### SAN DIEGO STATE UNIVERSITY MISSION VALLEY CAMPUS MASTER PLAN FINAL ENVIRONMENTAL IMPACT REPORT LATE LETTERS AND RESPONSES

January 2020

Comment Letter X1

### Response to Late Comment Letter X1

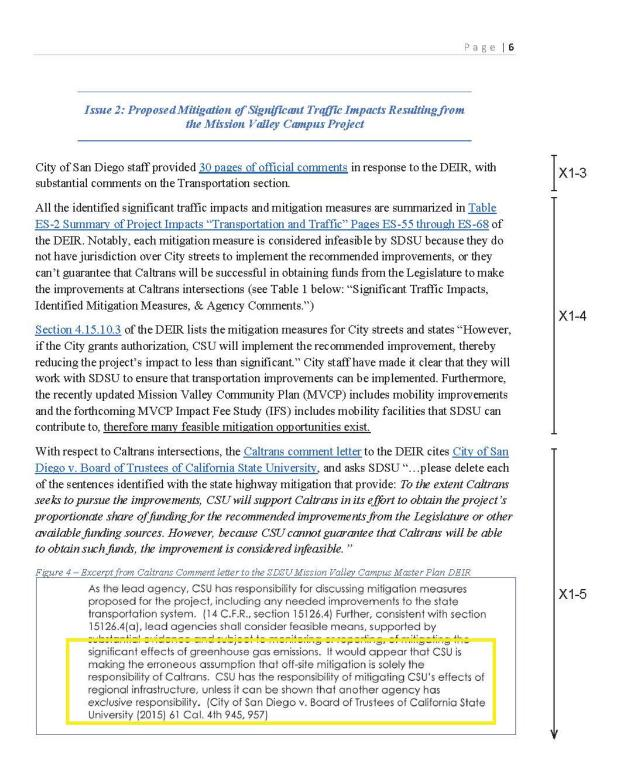
However, it is clear from the Transportation Impact Analysis (pages 71-72, 248) that those three improvements are project features, and not proposed mitigation to the project's traffic impacts Figure 2 - "Table 57" Page 248 of the Transportation Impact Analysis

(see Figure 2 below).

alculation of <u>the value of SDSU's proposed traffic mitigation to slightly over</u> <u>he \$18.4 million as the letter states</u> (see Figure 3 below).  Figure 3 - Corrected calculation of the value of SDSU's proposed traffic mitigation Streets SDSU Estimated Share Location Stadium Way to Fenton Parkway including Street I in the Mission Valley Community Plan St,160,000 Onsite Realign San Diego Mission Road to Mission Village Drive & Friars Road Westbound Ramps* \$7,300,000 Onsite Nission Village Drive & Friars Road Eastbound Ramps* \$6,700,000 Onsite River Run Drive & Friars Road Stadium Ave \$496,100 Offsite Fairmount Ave & San Diego Mission Road Rancho Mission Road \$276,592 Offsite Fairmount Ave & Mission Road \$276,592 Offsite Fairmount Ave & Mission Gorge Rd \$15,000 Offsite Northside Drive & Friars Road Stadium Calculation Stadius A Aero Drive Northside Drive & Friars Road Stadium Calculation Stadia St	10 <b>7</b> .

- X1-1 The comment is an introduction to comments that follow and provides a general overview of those comments that follow. Specific responses are provided below to the specific comments raised.
- X1-2 The comment regards the characterization of traffic-related improvements described in an October 14, 2019 letter from SDSU to the City. The issues raised question "onsite vs. off-site traffic impact mitigation."

Preliminarily, we note that the document referenced in the comment did not distinguish between improvements characterized as "mitigation" or "project features" but rather outlined all of the proposed traffic improvements related to City infrastructure. While the referenced improvements at "three specific intersections" are Project features and not mitigation, the referenced improvements, along with other traffic improvements identified in the EIR, represent a significant financial commitment on SDSU's part to improving the area's roads and are intended to improve traffic circulation in Mission Valley, especially along Friars Road. Specifically, the following traffic improvements addressed by the EIR, which include project design features, mitigation measures, and community benefit improvements over and above the project's mitigation requirements, demonstrate SDSU's commitment to improving circulation in Mission Valley:

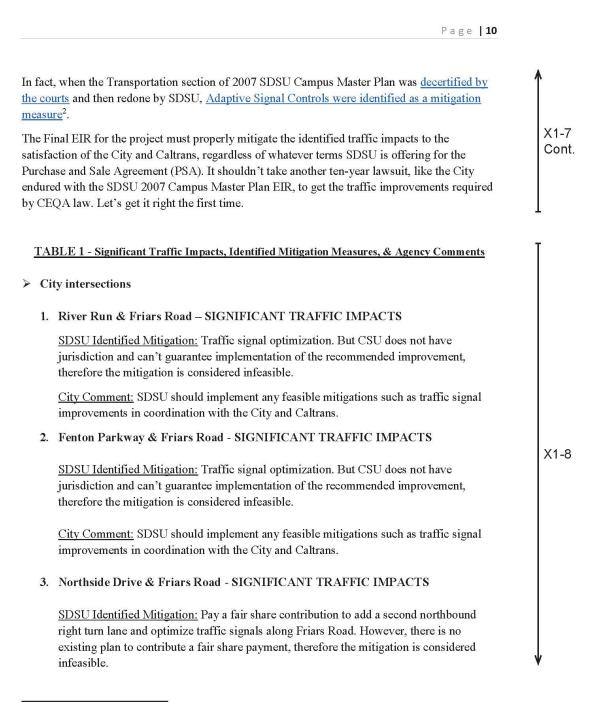
Page  8	
Figure 5 Excerpts	of Page 75 & 76 of the revised 2007 SDSU Campus Master Plan	٨
Near-Term	(2022) Mitigation Measures	1
Intersection	<u>s</u>	
AATCP-1	College Avenue / 1-8 Eastbound Ramps (Intersection #8). The improvement necessary to mitigate the Project's significant impact at the College Avenue / 1-8 Eastbound Ramp is to widen the northbound College Avenue approach to the on-ramp to provide an additional lane on College Avenue between Canyon Crest Drive and the 1-8 EB on-ramp. Prior to SDSU Full-Time Equivalent (FTE) enrollment reaching 25,056 <sup>4</sup> or its equivalent. SDSU shall commence and to the extent feasible complete construction of the widening of the northbound College Avenue approach to the College Avenue / 1-8 Eastbound Ramp to provide an additional (third) northbound lane between Canvon Crest Drive and the 1-8 EB on-ramp by the identified trigger, to the reasonable satisfaction of the City of San Diego City Engineer and Caltrans. To implement the improvements, SDSU shall prepare design plans and submit such plans to the City of San Diego and Caltrans for review and approval. Following City and Caltrans approval, SDSU shall obtain any necessary construction permits and provide bond assurances to the reasonable satisfaction of Caltrans and the City Engineer prior to constructing the subject improvements consistent with the approved City and Caltrans plans. In the event the proposed improvements are not approved and constructed by the above identified trigger, the impact would remain temporarily significant and unavoidable until approval and construction of the improvements, but in no event shall said improvement be delayed beyond the identified trigger without good cause and reasonable coordination with the City of San Diego Engineer, (Note: The phrase "or its equivalent" as used in this and other mitigation measures refers to the fact that the near-term construction of the Adobe Falls Eaculty/Staff Housing could trigger the identified significant impact prior to FTE enrollment actually reaching the designated number, in this case, 25,056, Accordingly, Table AA3,14-34, Mitigation Trigger Analysis, of this Draff Additional Analysis, identifies the nu	X1-5 Cont

Page <b>  9</b>	
<u>I will be looking to see this level of commitment and specificity in the final EIR for the Mission Valley Campus project.</u>	X1-5 Cont.
A provision of SDSU's offer letter(s) that needs clarification is the proposed \$5 million for additional traffic improvements. In the Oct. 14 <sup>th</sup> offer letter, item number 12 states "As described in the DEIR, SDSU intends to provide approximately \$21,000,000 in off-site and major on-site improvements, pursuant to the mitigation measures identified in the DEIR. SDSU will also provide \$5,000,000 in additional traffic improvements as an accommodation to the City, provided SDSU does not become responsible for other traffic improvements."	Ī
In SDSU's <u>Oct. 15<sup>th</sup> letter</u> which describes the planned \$21 million in transportation improvements and erroneously attributes \$17.4 million as off-site when it is actually on-site, it states "Per SDSU's offer letter, SDSU will also provide \$5 million in additional traffic improvements as an accommodation to the City, provided SDSU does not become responsible for other traffic improvements."	X1-6

X1-5 The comment regards mitigation relating to Caltrans facilities and references the SDSU 2007 Campus Master Plan litigation. The 2007 Master Plan litigation addressed SDSU's mitigation obligation relative to City facilities and it resulted in the requirement that SDSU mitigate the identified impacts to those municipal facilities.

As to the 2007 Master Plan mitigation measure AATCP-1 referenced in the comment, the mitigation primarily regards the widening of a City of San Diego facility – College Avenue, not a Caltrans facility. As previously noted, all of the Mission Valley EIR proposed mitigation measures relating to City facilities have been revised consistent with the 2007 Master Plan approach. Please also see X1-8 below.
